AIR CONDITIONING - ENVIRONMENTAL SYSTEM WIRING MODIFICATION FOR LOW FLOW IMPROVEMENT

MODEL	SERIAL NUMBERS
Super King Air B200GT	BY-207, BY-239, BY-250 thru BY-381
Super King Air B200CGT	BZ-1

MTB-21-01
Page 1 of 5

Figure 1. Low Flow Improvement Wiring Modification (Sheet 1)

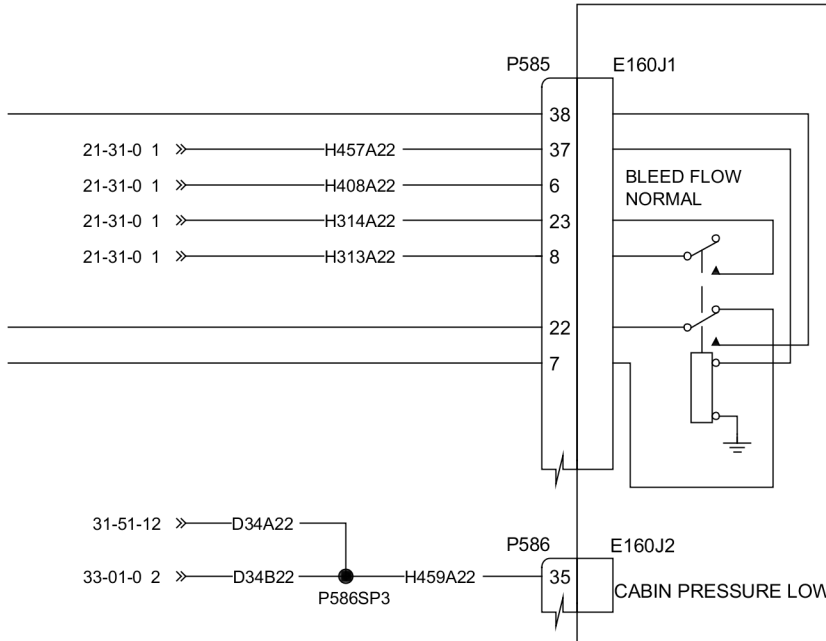
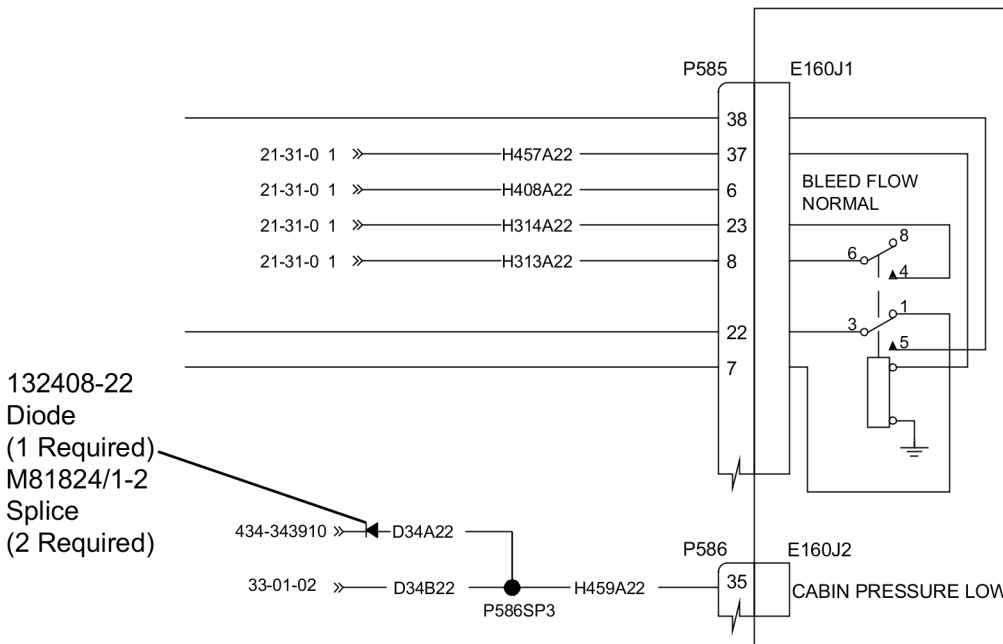
Due to stray voltage, the flow control system will sometimes not run in low flow mode when commanded. Environmental system requires diode isolation to allow operation in Low Flow setting. Without this change, system may continue running in Hi Flow regardless of setting.

3. Do the wiring modification.
 - A. Cut the D34A22 Wire.
 - B. Slide the 106242G44-00400 Heat Shrink Tubing onto the D34A22 Wire.
 - C. (Refer to Figure 1.) Install the 132408-22 Diode on the D34A22 Wire with two M81824/1-2 Splices. (Refer to the King Air Standard Practice Chapter 20 – Airframe, Electrical Wiring – Maintenance Practices).

- D. Install the 106242G44-00400 Heat Shrink Tubing over the Diode.
 - E. Use the heat gun to heat and shrink tubing.
4. Remove the maintenance warning tags and connect the airplane battery.
